SUBSURFACE EXPLORATION AND TESTING PROGRAM TO EVALUATE GROUNDWATER
QUALITY AND PRE-TREATMENT DESIGN PROGRAM AT THE WAUSAU CHEMICAL
FACILITY IN WAUSAU, WISCONSIN

STS JOB 12776A

RE: Subsurface Exploration and Testing Program to Evaluate Groundwater
Quality and Preliminary Extraction and Pre-treatment Design Program at
the Wausau Chemical Facility in Wausau, Wisconsin.

Wausau Chem - Questions on Rpt.

FIGURE 1

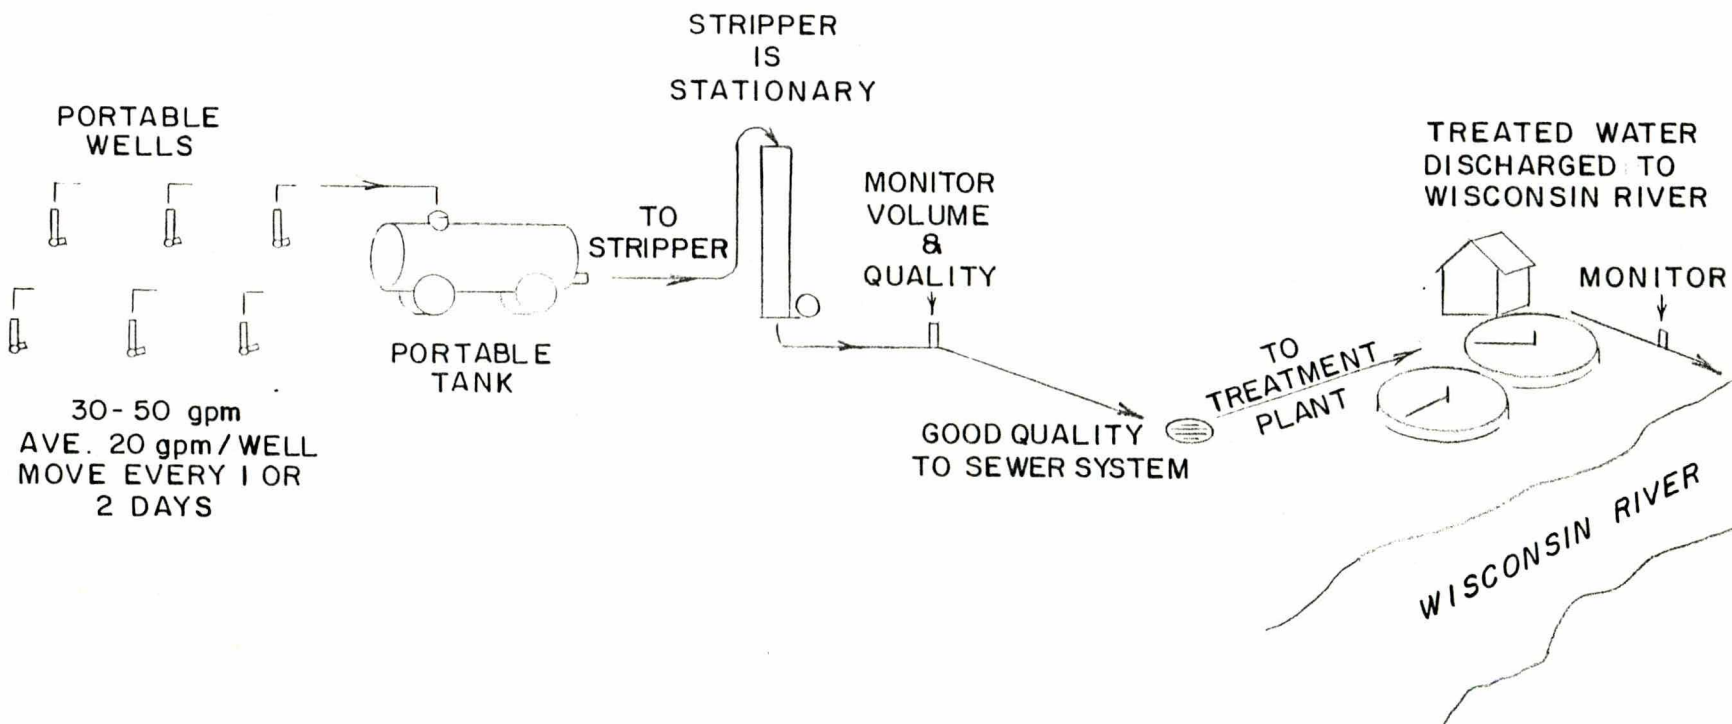
- Questionable that a portable system would be adeq. for the long-term removal required at a contamin. site.
- Hi-cap discharge permit for water supply Bureau
- Monitoring of system
 - water levels, gw flow
 - periodic water analysis - how often? Probably do more initially, then go to Routine monitoring (1 x/wk?)
- p. 12 - plan to terminate extraction at an area when no change occurs from 2 consecutive samples. This plan is v. dependent on frequency of sampling. We must also consider NR140,
 - TCE = 1.8 ppb PCE = 1.0 ppb VC = 0.015 ppb
 - Benzene = 0.67 ppb Toluene = 343 ppb Xylene = 620 ppb

→ To start @ the tank farm + expand immmed. east + south if necessary. The area around the water trt plant, at least to wells B-6, 6A + up to B-5, 5A. Extension to the area east of well 4, near the RR tracks should also be considered.

GROUNDWATER CONTOURS
PUMPS 3 & 4 ON
1-21-85
CITY OF WAUSAU, WISCONSIN

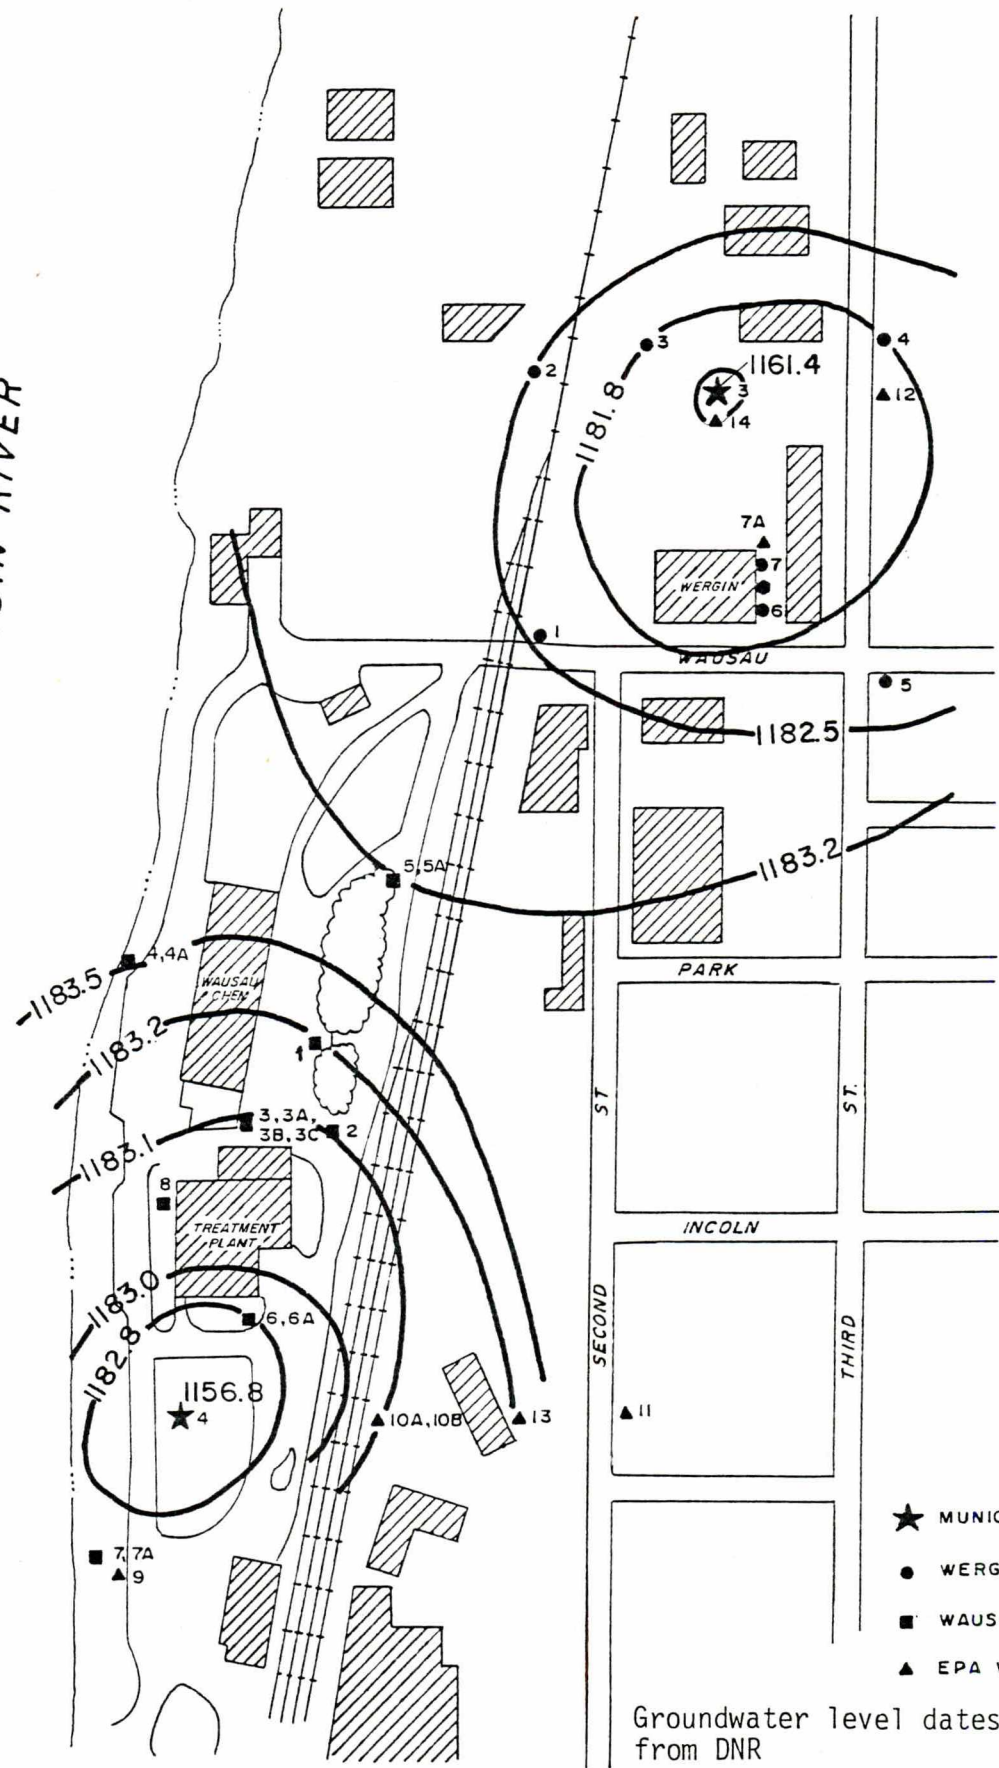
- Add'l Work near EPA-10A,B. GW flow map when Well #4 off shows gw flow toward SE, indicating W.C. could be source for contamination @ EPA-10A,B.
- GW maps only when City Wells 3 + 4 pumping. DATA when #4 is off? Impt because this was the case for a number of years. Any add'l plans for water level meas. this summer? (expt w/ #4 should be done). Are there any plans to shut well #4 off or can it be done for a time?
